URBAN DESIGN CONSULTATION RESPONSE

Design Officer	Azhar Kapadi / Mike Atkinson Smith
Date	18.12.24 (MAS) 23.05.25 Set 2 Comments
Application Reference	24/01120/FUL
Address	Lancashire Dog Training And Behaviour Centre , Bamford Road, Heywood, Rochdale, OL10 4TF
Proposal	Demolition of existing building and erection of three storey building comprising 6no. two bed apartments with associated car parking, boundary treatments, bin store and landscaping

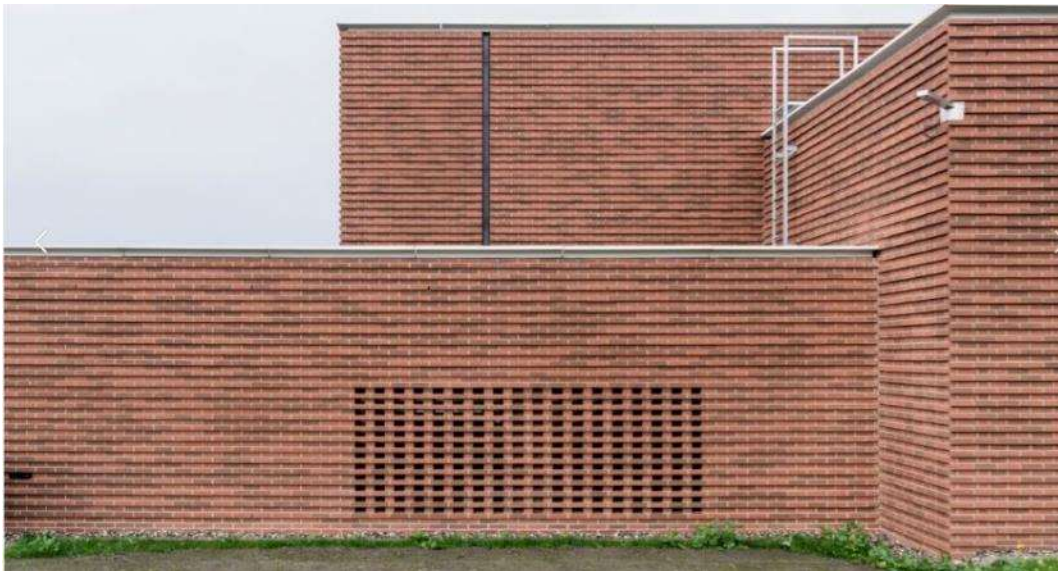
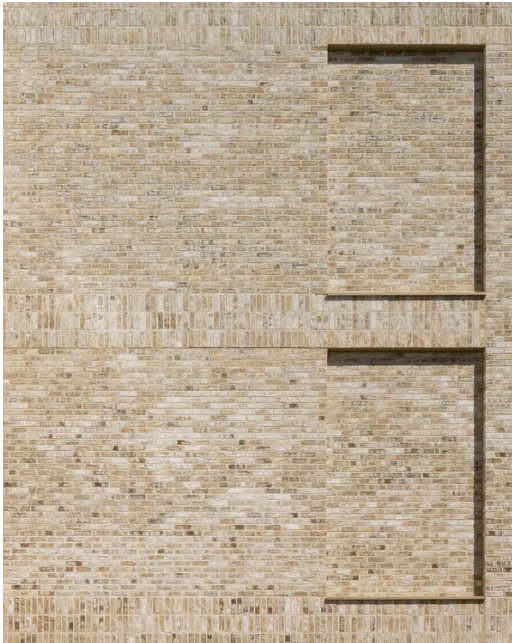
An opportunity has been missed to introduce landscaping and screening buffers to the site. The immediate context does have hedgerows and trees to the boundaries and this site would certainly benefit from some screening, considering the scale and design of the development. Similarly the outlook for residents to the rear is poor and landscaping would have helped improving this. The parking arrangement appears quite constrained but Highways would be better advising.

The boundary details/ materials proposed are equally as uninspiring, not utilising an opportunity to improve some of the poor boundary treatments that exist already on the site. Have the stone walls to the front boundary at least been maintained? Clarify what the green circles on the front lawn are.

The site does seem over constrained and would benefit from a 1:50 site plan to understand exactly how the building fits into the site in context with the fencing and access road to the rear car park shown in greater clarity.
